ORIGINATION FORM

Proposed Revisions to a Standard Plans Index
(Please provide all information — Incomplete forms will be returned)

Index Number: 515-070

Index Title: Pipe Guiderail (Aluminum)

LAST REVISION	DESCRIPTION:	FY 2020-21 STANDARD PLANS	PIPE GUIDERAIL (ALUMINUM)	INDEX 515-070	SHEET 5 of 5
11/01/17

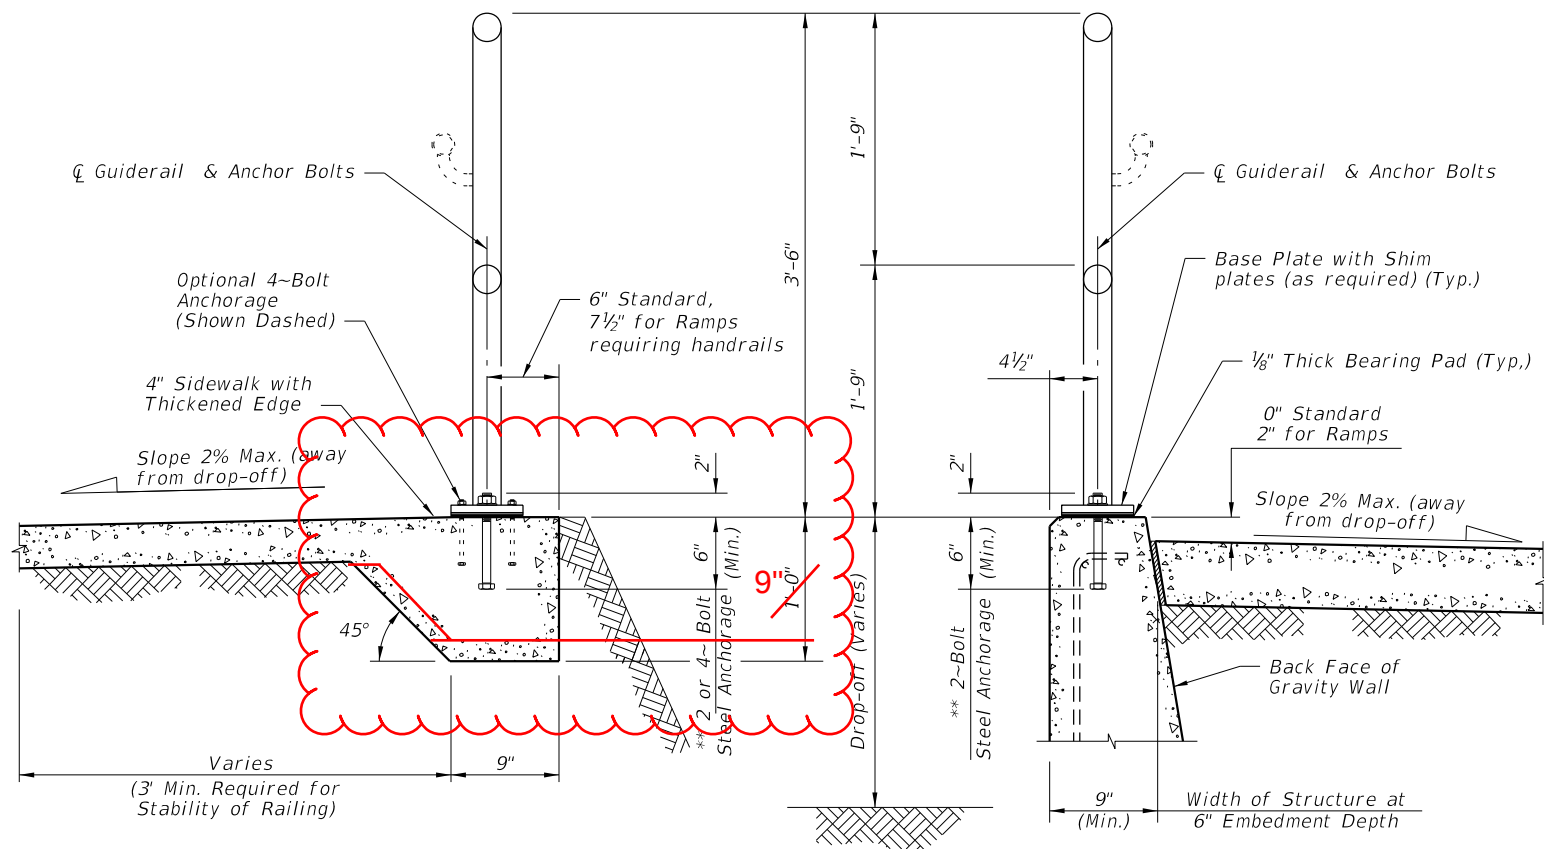
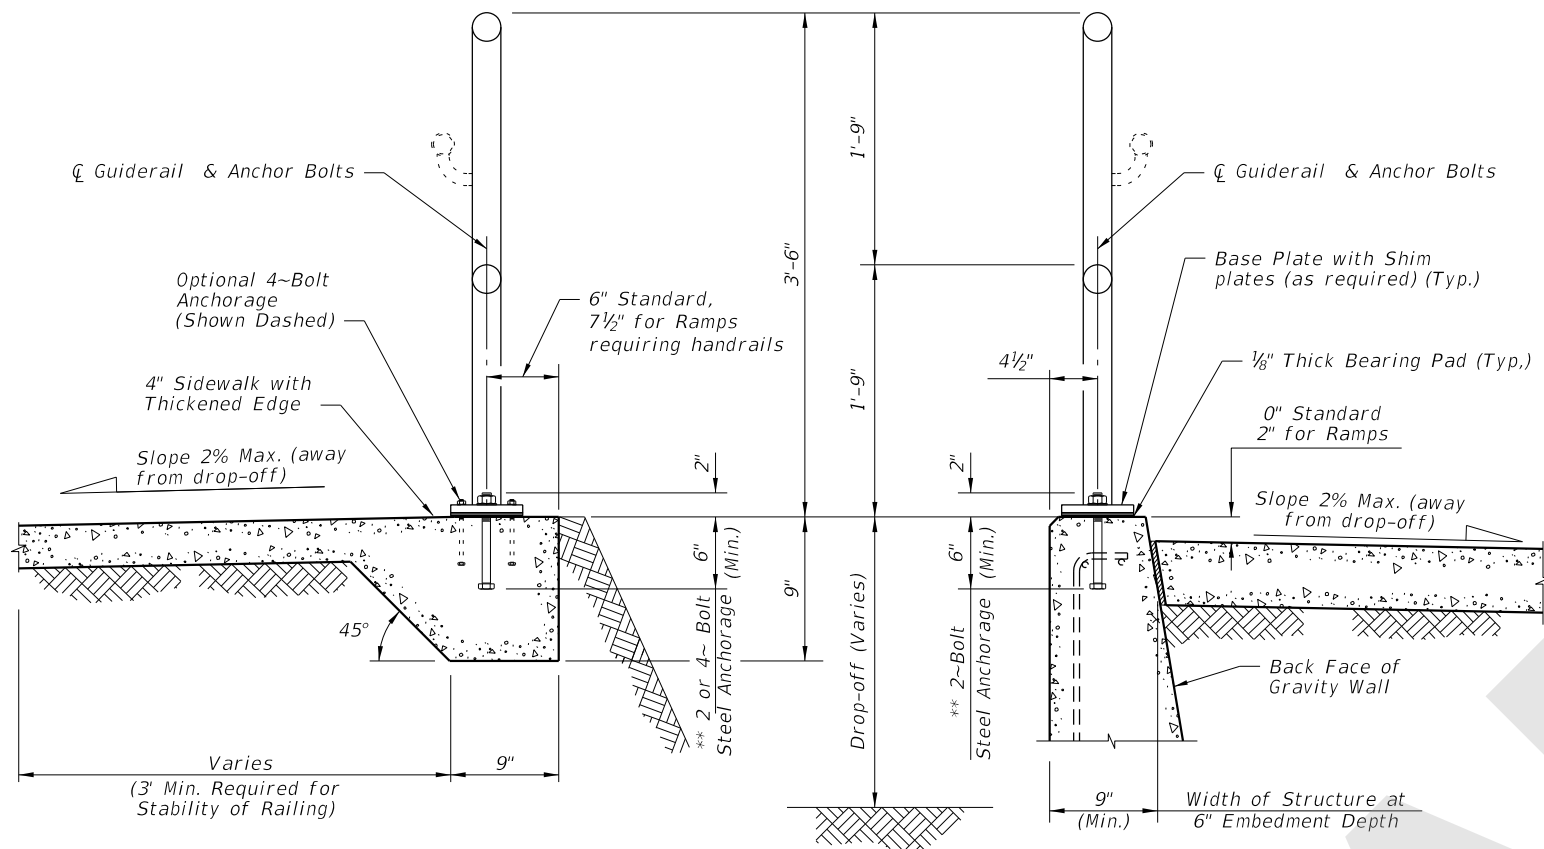
Change edge beam of sidewalk to 9" deep.

Due to research, embedment was reduced to 6"; therefore, the depth can be reduced to 9".
